**REPUBLIC AVIATION CORPORATION
FARMINGDALE, LONG ISLAND, NEW YORK
SERVICE DEPARTMENT**

SERVICE BULLETIN NO. 18

INSTALLATION OF ANTI-SWIRL VANES IN CARBURETOR AIR DUCT

Figure 1

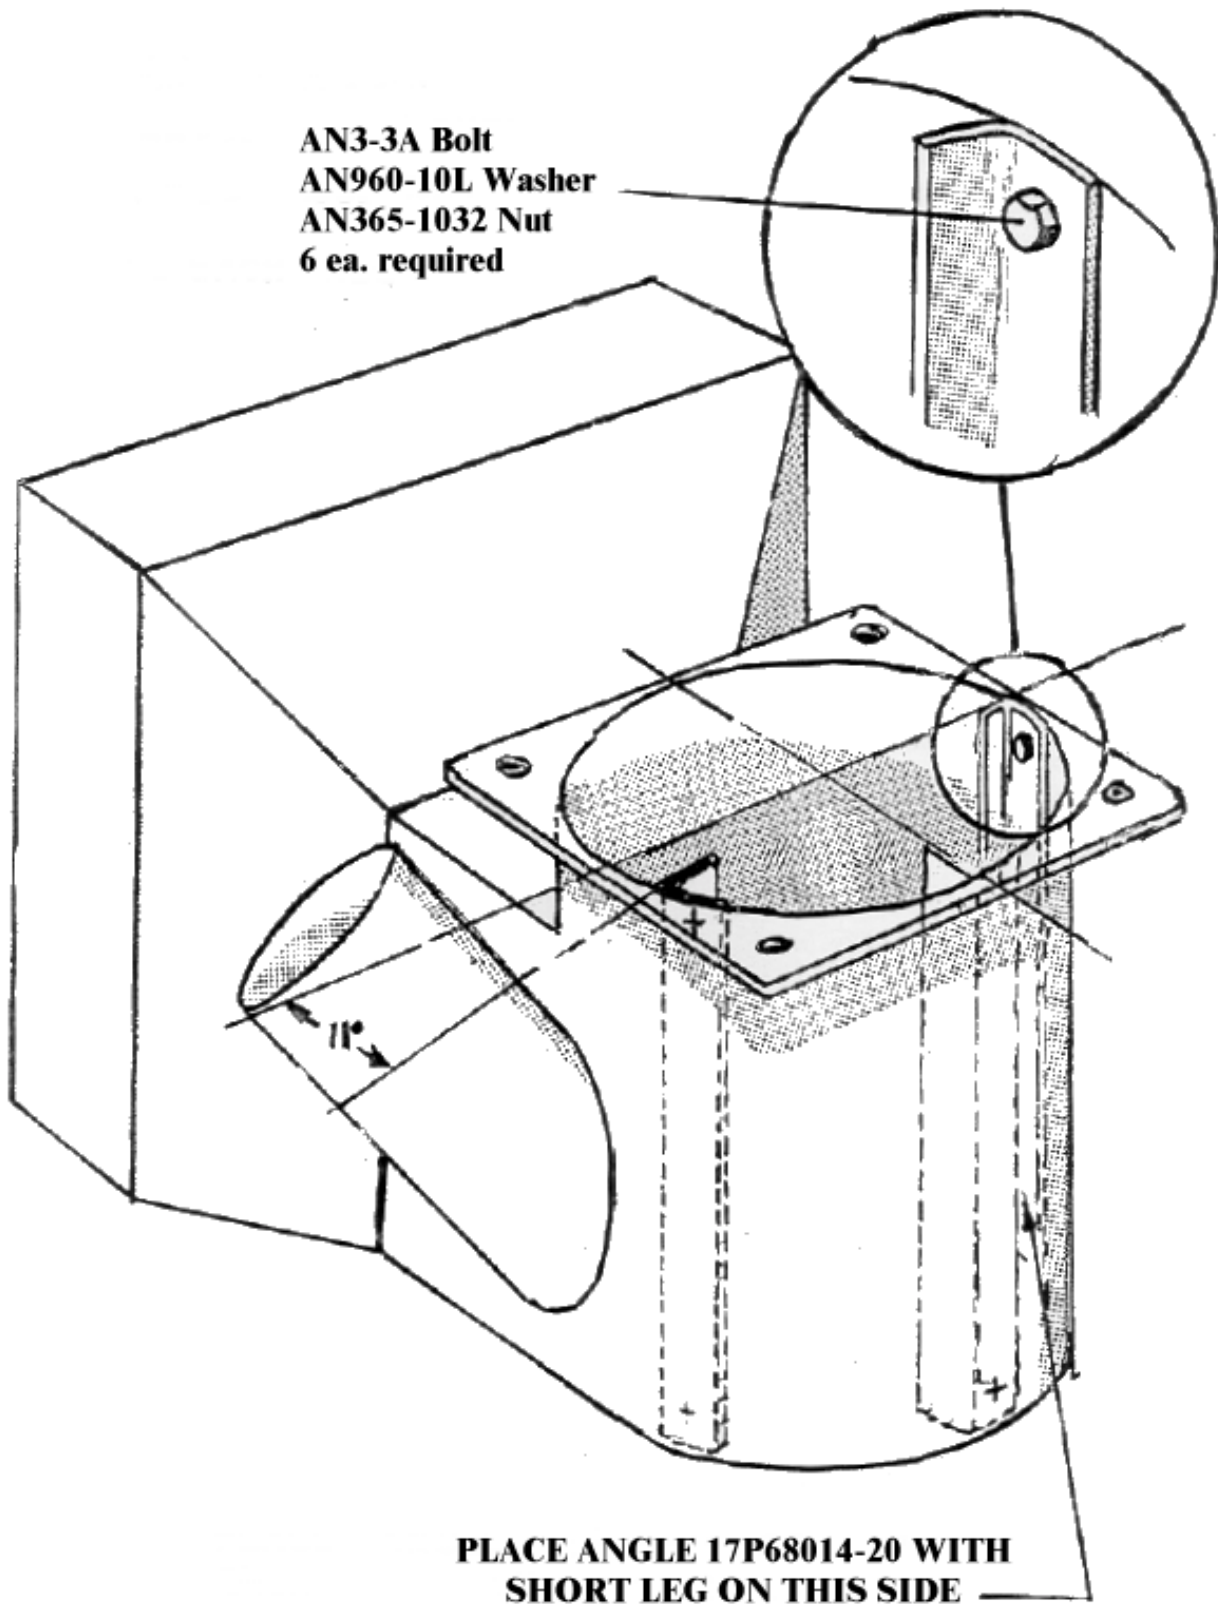
Reason for Change: To prevent excessive R.P.M. drop off when carburetor heat is used. The addition of the anti-swirl vanes straightens the flow of air to the carburetor thereby preventing an excessively rich mixture when carburetor heat is used. This is a Mandatory Change and should be incorporated before icing conditions are encountered.

Description of Change: This change involves removing the carburetor, installing the anti-swirl vanes in the air duct below the carburetor and reinstalling the carburetor.

1. Open top engine cowl.
2. Disconnect upper and lower carburetor flange studs, fuel lines and mixture and throttle controls at carburetor.
3. Since upper studs are threaded into the intake manifold, it is necessary to hoist up aft end of engine, which will withdraw these studs from the upper carburetor flange and permit removal of carburetor. Therefore, hoist aft end of engine to clear carburetor flange studs and remove carburetor. If a hoist is not available, 2 x 4 wood planking and an automobile jack can be used to jack up the rear of the engine.
4. Locate anti-swirl vanes as indicated in Figure 1, drill #10 (.193) holes through air intake duct to match holes in vanes and attach vanes with AN3-3A bolts, AN960-10L washers and AN365-1032 nuts provided. Washers and nuts are to be on the outside of the air intake duct.

NOTE: Be sure to install vane with shorter leg in proper location.

5. Clean out all drill chips from the air intake duct. Check operation of heat control valve.
6. Reinstall carburetor and attach fuel lines and mixture and throttle controls at carburetor.
7. Run up engine and operate carburetor heat control. Under normal conditions the drop off should not exceed 275 R.P.M. with heat control in any position.
